**HUMBOLDT STATE UNIVERSITY
JENKINS HALL**

SEISMIC EVALUATION

February 6, 2018 (DRAFT)

FOUNDATION PLAN
Scale 1/4" = 1'-0"

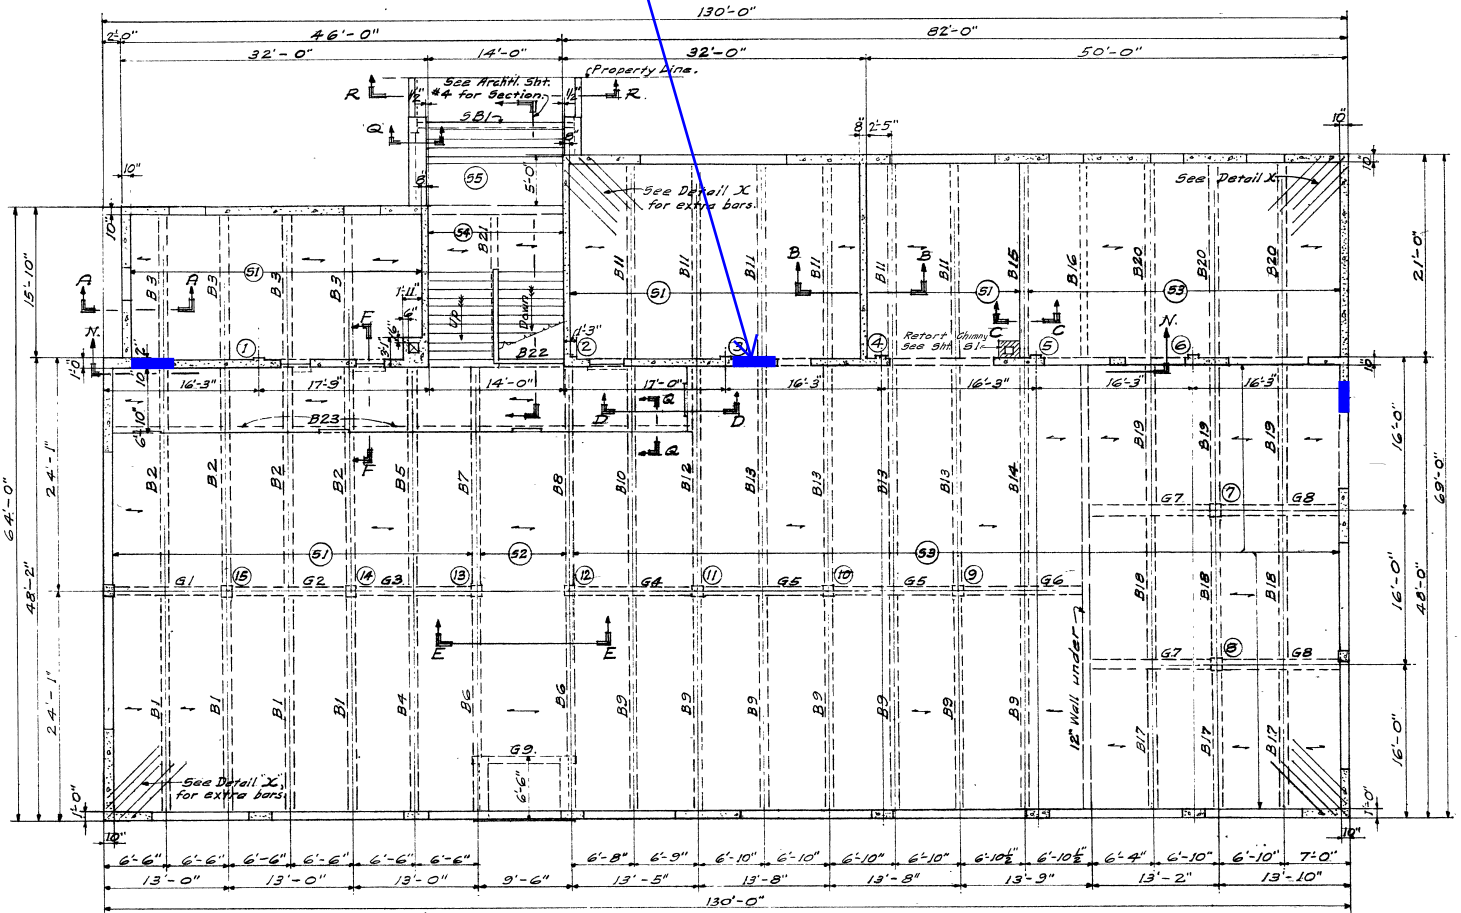
EXISTING STEPPED FOOTINGS
EXPOSED IN ROOMS PROPOSED FOR
RENOVATION: CANNOT DEMO
WITHOUT EXTENSIVE FOUNDATION
SHORING, UNDERPINNING AND
RECONSTRUCTION

WALL PIER DEFICIENCY:
INCREASE SIZE FOR
ADDED STRENGTH

NEW OPENING IN CONCRETE WALL
PER CURRENTLY PROPOSED
RENOVATION SCHEME, TYP

ROOF FRAMING PLAN.
Scale: $\frac{1}{8}'' = 1'-0''$

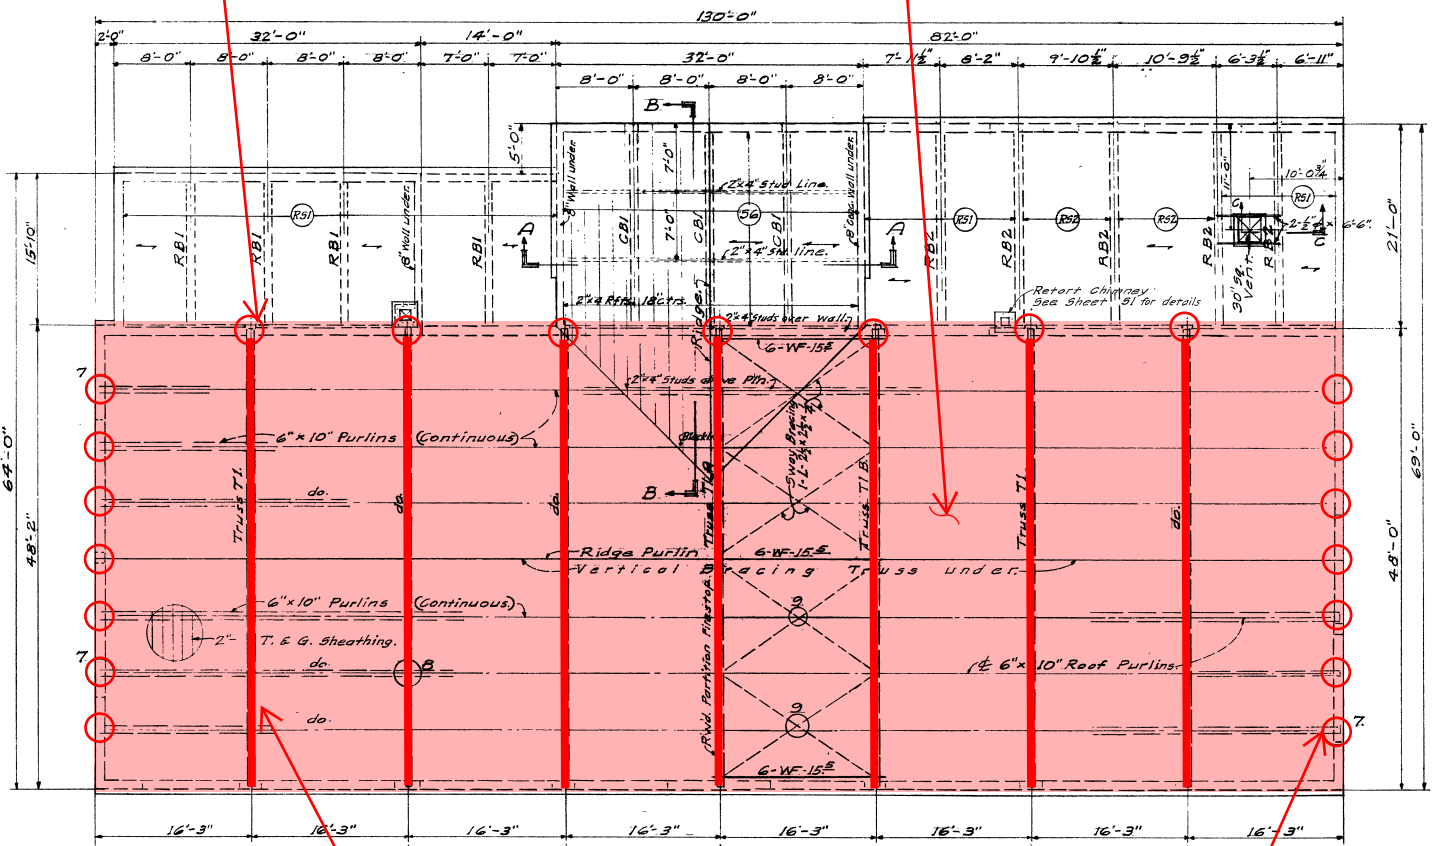
DIAPHRAGM TIE DEFICIENCY:
PROVIDE NEW CONNECTIONS BETWEEN
WOOD AND CONCRETE DIAPHRAGMS,
TYP AT EACH TRUSS LOCATION

DIAPHRAGM DEFICIENCY:
STRENGTHEN DIAPHRAGM BY
PROVIDING NEW PLYWOOD
SHEATHING OVER EXISTING 2x
STRAIGHT SHEATHING

WALL ANCHORAGE DEFICIENCY:
STRENGTHEN CONNECTION OF WALL TO
PURLIN, TYP AT EAST AND WEST WALLS

WALL ANCHORAGE DEFICIENCY:
PROVIDE NEW BLOCKING TO CONNECT
DIAPHRAGM TO TRUSS, TYP AT EACH TRUSS
